SYDNEY CENTRAL CITY PLANNING PANEL

COUNCIL ASSESSMENT REPORT

Panel Reference	PPSSCC-102
DA Number	DA/1157/2016/H
LGA	City of Parramatta Council
Proposed Development	Section 4.55(2) modification to DA/1157/2016 for a concept plan for 4 stage mixed use development, specifically amendments to approved building envelopes including increases in height, amendment to approved uses, reallocation of floor space & deep soil, deletion of redundant condition and revised timing of approved public domain upgrades.
Street Address	657-661 Victoria Road & 4-6 Wharf Road MELROSE PARK NSW 2114 (SP102190, Lot 11 DP1238936, Lots 2 & 3 DP 588575)
Applicant	M Projects Pty Ltd (on behalf of Payce)
Owner	Tyriel Developments Pty Ltd
Date of lodgement	25 May 2020
Number of Submissions	One
Recommendation	Approval subject to revised conditions
Regional Development Criteria	The proposal is a s4.55(2) modification to an application with a capital investment value of more than \$20 million (criteria at time of lodgement) and the application seeks to vary a development standard by more than 10% (height).

Figure 4. Envelopes on adjoining site to the south as currently envisaged by Melrose Park North Planning Proposal.

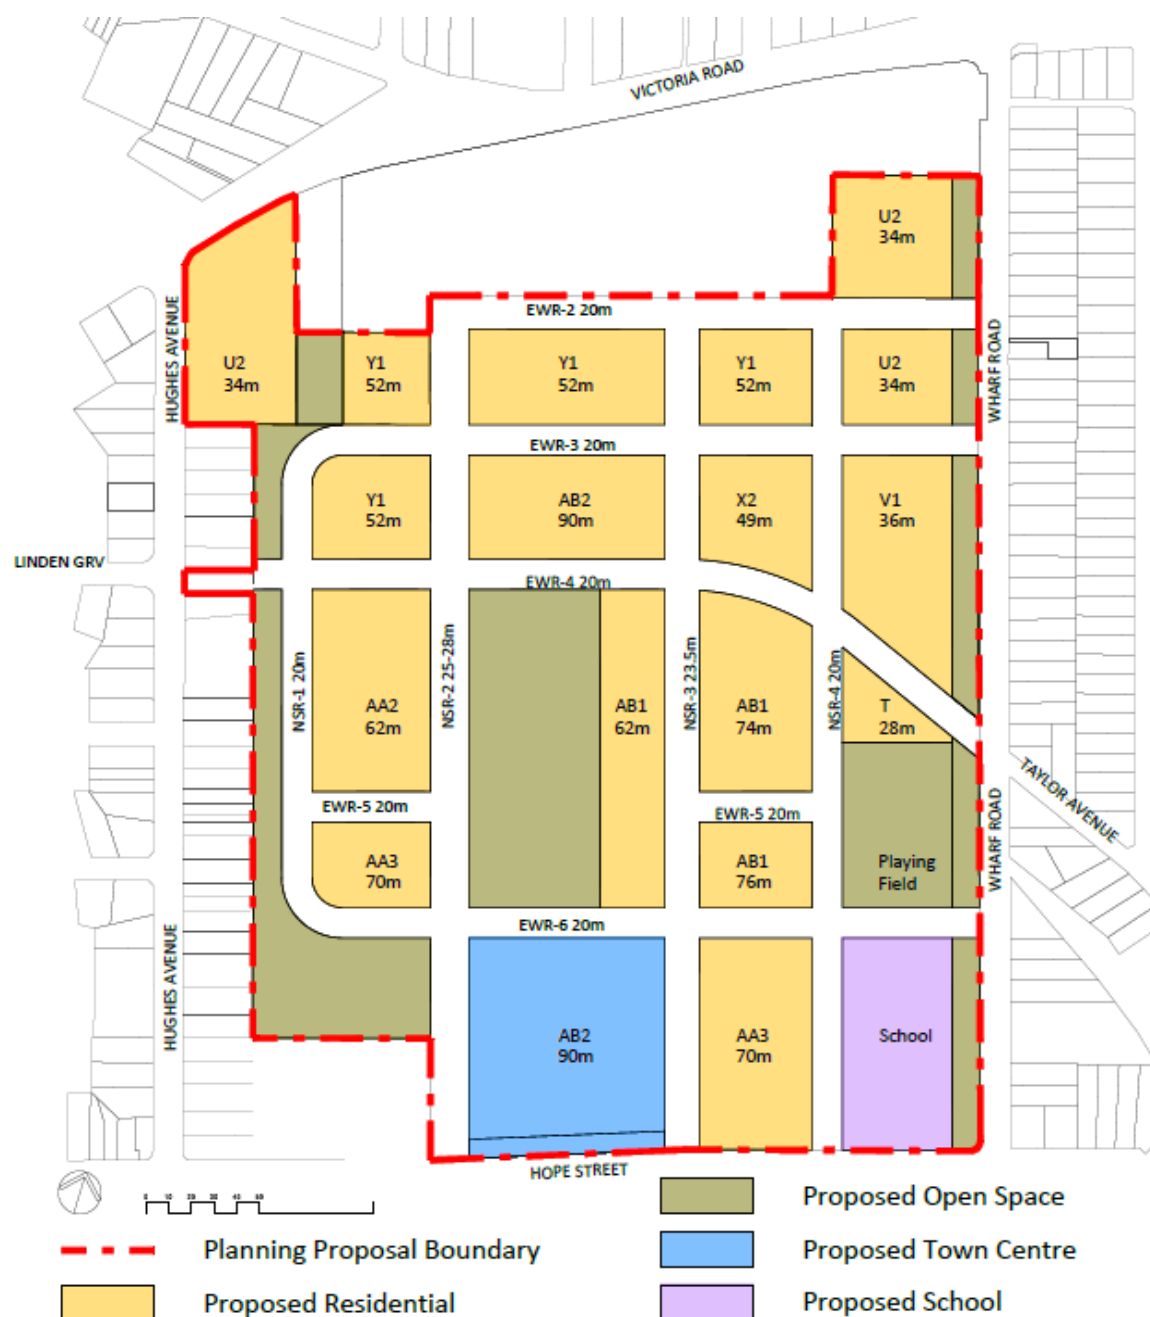
The applicant notes that the latest planning proposal documents for the adjoining site to the south now no longer includes a town centre adjacent the site (See Figure 5 above).

- The latest planning proposal documents do show that the town centre will be located well south of the subject site.
- Regardless, the detailed design of the town centre is not likely to be confirmed for some time and as such it is unlikely that the design of Stage 4 (concurrently under assessment) would be able to respond with any certainty to such a condition.

Deletion of the condition is considered to be acceptable for the following reasons:

Figure 5. Concept Plan as proposed to be modified.

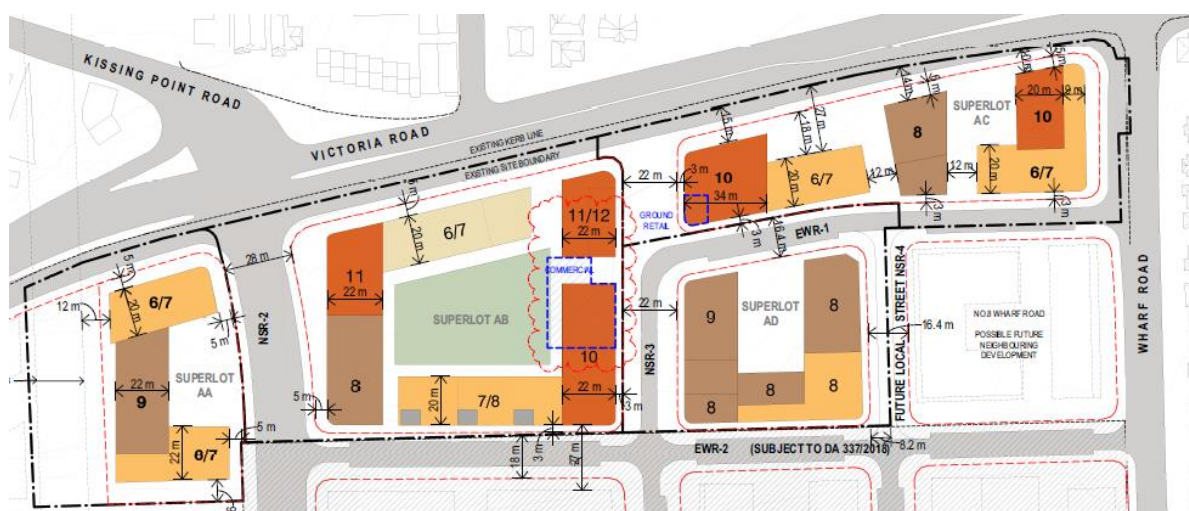
- Distribution of 67m² of unutilised floor space from Stage 2 to Stage 4;
- Reallocation of 1,430m² of Stage 4 commercial floor space back to residential floor space;
- Increase in the estimated number of Stage 4 residential units from 408 to 426 (+18);
- Change of use of childcare centre to medical centre;

- Modification to building envelopes of Stage 4:

Block	Height Change (storeys)	Height Change (metres)	Footprint Change (square metres)
North-East	+1-2	+3.75m	-130m ²
South-East	N/A	+0.85m	175m ²
South	N/A	+3.45m (lift overruns only)	+105m ²
South-West	N/A	+2.95m	+330m ²
North-West	+1	+4.45m	-330m ²
North	+1	+4.15m	N/A

- Separation between north-east and south-east buildings reduced from 13m to 11m;
- Separation between south and south-west buildings reduced from 12m to 6.5m;
- Reduction in Stage 4 deep soil from 1,900m² to 983m² (-917m²);
- Delete requirement to avoid overshadowing adjoining town centre; and
- Defer undergrounding of power lines along Victoria Road from prior to *any* OC for Stage 4 to prior to *final* OC for Stage 4.

The above modifications require updates to concept plan conditions 1, 3, 7, 10, 28. For draft revised wording please see Appendix 1.

Figure 6. Cut and Fill Plan of non-basement areas within site (Darker the Green = More Fill, Darker the Red = More Cut).

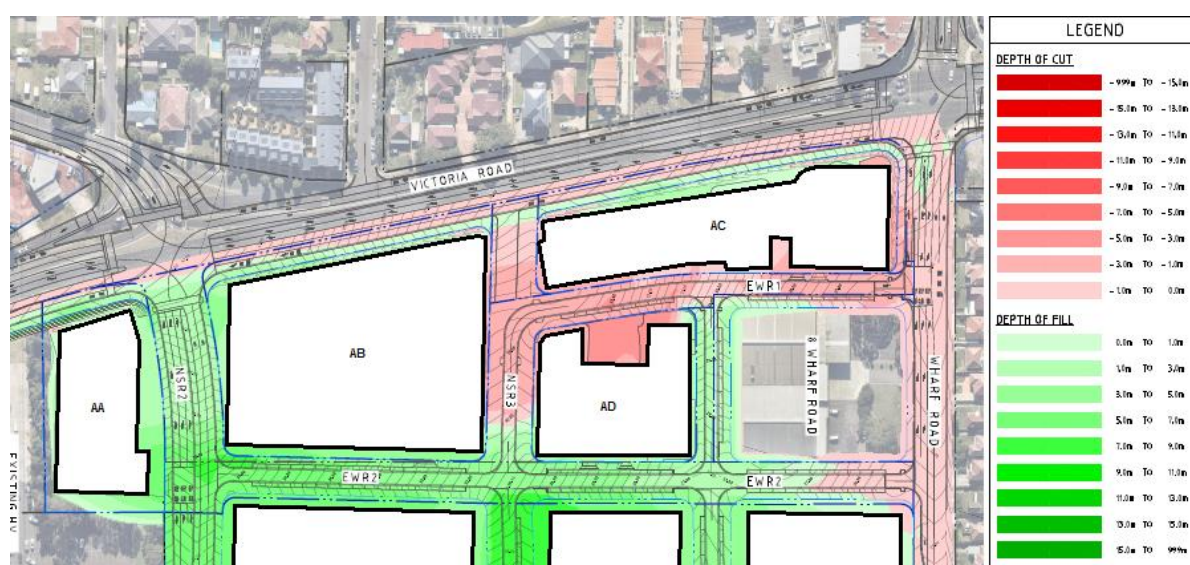
The need to further increase the envelopes is owing generally to the following site constraints:

- Significant Grade Change – The desirable planning outcome of regrading the site, including significant fill in parts, to accommodate a shallower pitch. This regrading will maximise accessibility, provide for the required vehicular connections, and ensure that units do not have to be accommodated substantially below surrounding ground level. The proposed regrading is outlined in Figure 9 below.
- Overland Flow Flooding - The need to have ground level units at least 500mm above the adjoining public domain to protect against overland flow hazard. The overland flow hazard has become more pressing owing to recently completed modelling of the Probable Maximum Flood (PMF) event.

- As outlined above, the mapped height limit for the site under clause 4.3 of the Parramatta LEP 2011 is 28m above *existing* ground level. In order to achieve appropriate street gradients in the precinct, significant fill is required around the Stage 4 site, particularly in the north-west corner (see image below). This results in the proposed ground level being higher than the existing ground level and thus exacerbates the height non-compliance. In other words the buildings will not look as tall as the height non-compliance suggests. In fact, if the regrading works were undertaken as part of a separate application and completed prior to submitting the associated detail application for Stage 4, the non-compliance would be less.

Figure 7. Building Envelope Height Breaches as originally approved (28m building height plane in red).

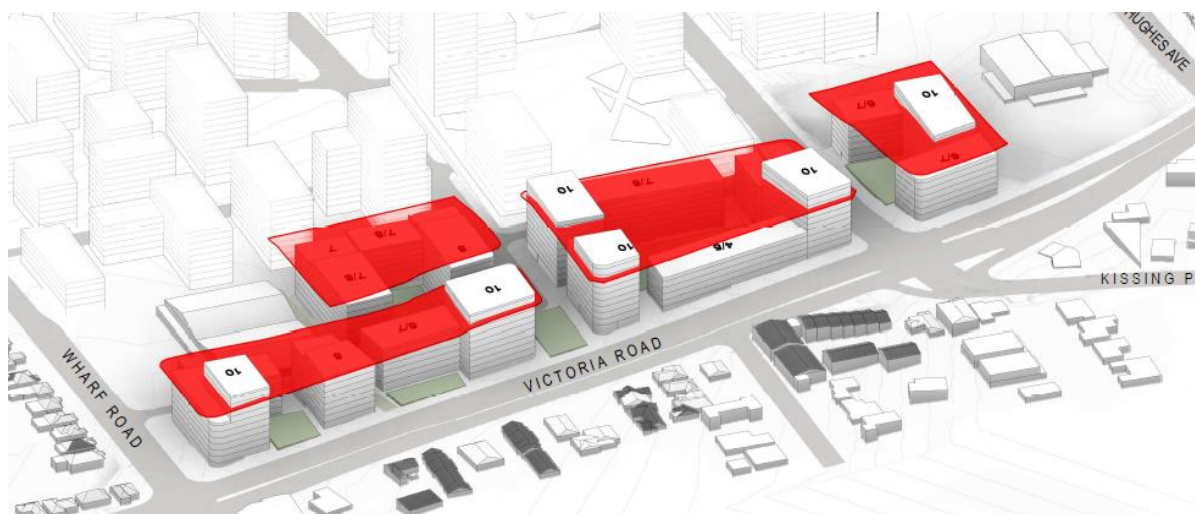
The proposal also includes other minor breaches of the height limits as well as height increases to other envelopes which would remain below the height limit. A comparison of the approved versus proposed breaches is outlined in the figures below.

- The original justifications for the height non-compliance outlined in the Clause 4.6 request submitted with the original application continue to have merit.

- The proposal achieves a discernible variance in height across the site. Complying envelopes may be able to accommodate the allowable floor space but this would result in monotonous and unbroken rows of 8 storey buildings.

- Council's Urban Design team and DEAP support the changes.
- The proposed 9-12 storeys elements constitute just 11.1% of the site area.
- The applicant has demonstrated that the revised envelopes do not prejudice the ability of the future applications to provide sufficient deep soil planting and landscaped open space (see Section 6.1.5 below).

The modification is considered to be acceptable for the following reasons:
